**TECHNICAL INSTRUCTION  
HAC10-002 Rev. N/C, Jan. 13, 2010**

**INSTRUCTIONS FOR CONTINUED AIRWORTHINESS**

**JA161T6046-3A Spring & JA161T6047-9A Spool Assembly  
INSTALLED ON  
Boeing 767 Aircraft**

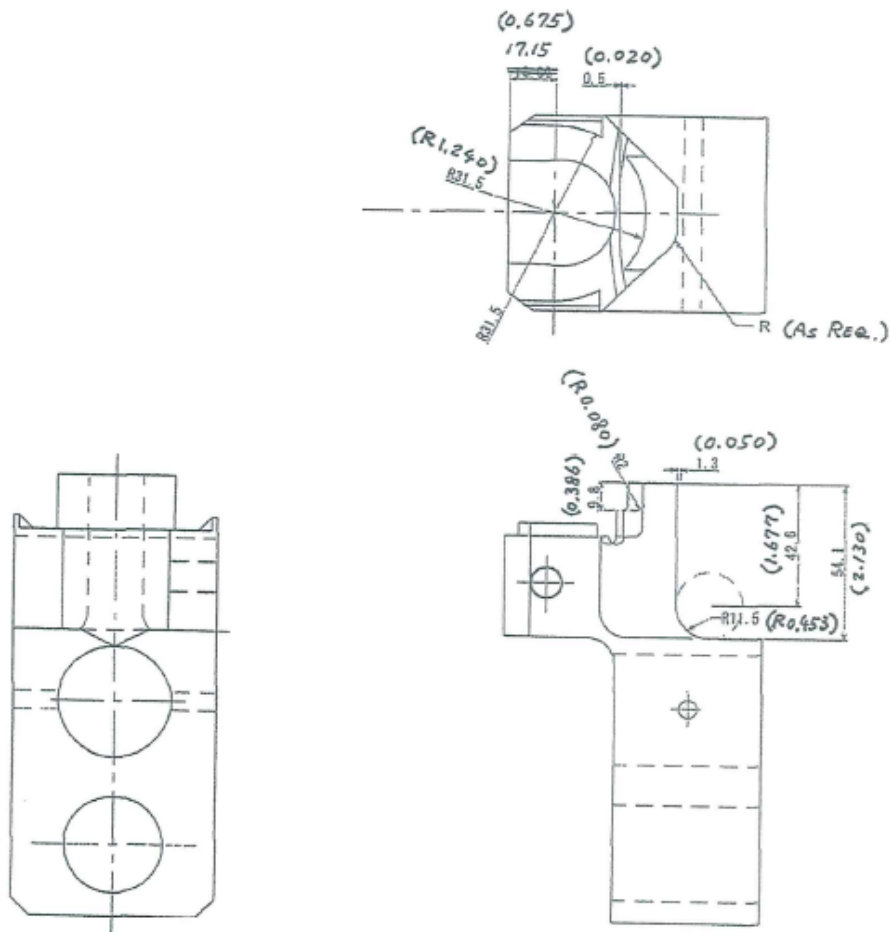
2.2 - JA161T6046-3A Springs must be used with two JA161T6047-9A Spool Assemblies as spring hook size diameter is smaller than that of 161T6046-3. Similarly, JA161T6047-9A Spool Assemblies must not be used with 161T6046-3 Springs.

2.5 - (cont'd) Modify Spring Extender Tool A32099-77, Detail A32099-42 as shown. Dimensions in mm (inches):

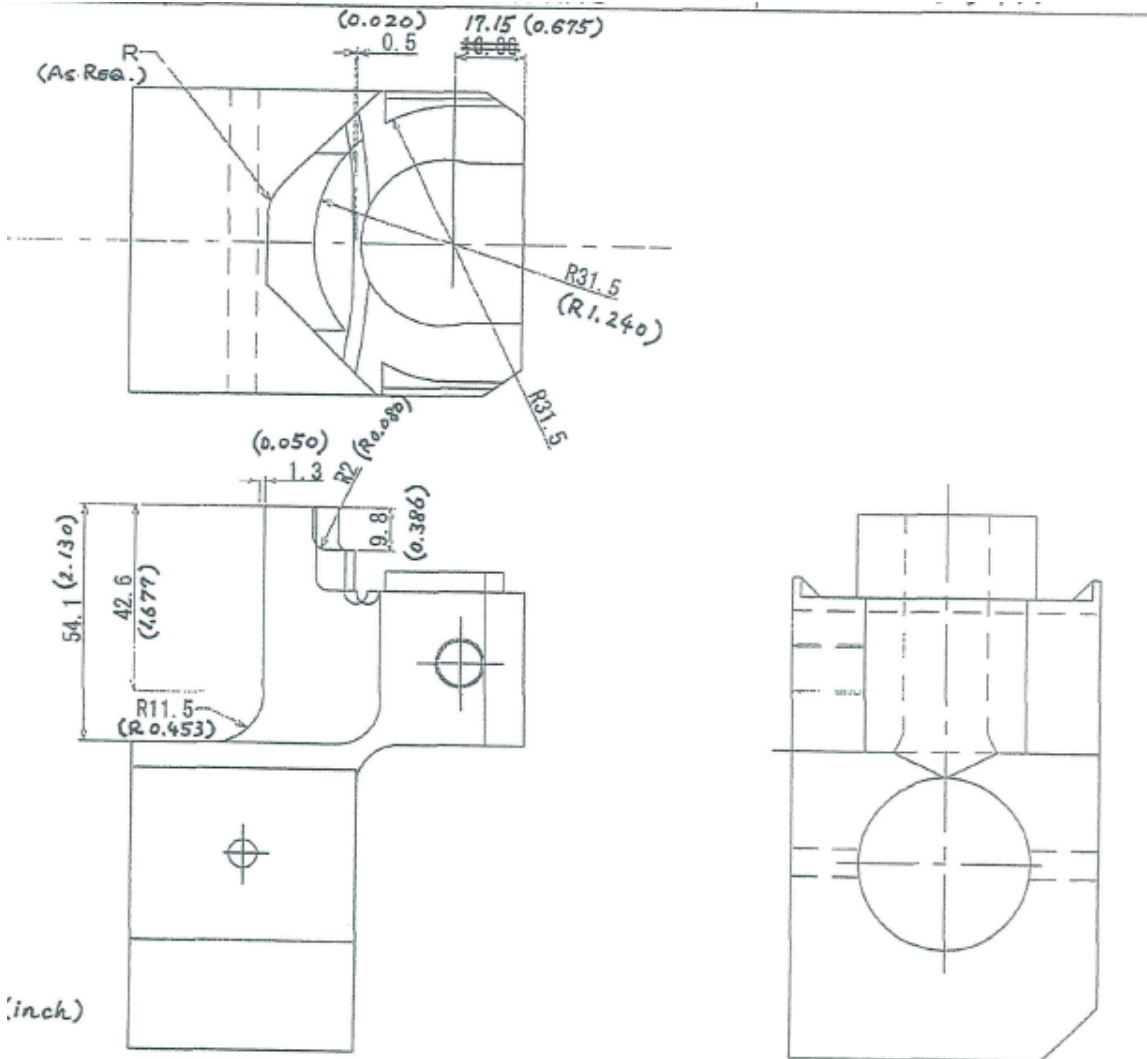
2.5 - Installation tools used for 161T6046-3/161T6047-9 Spring/Spool sets must be modified as shown below.
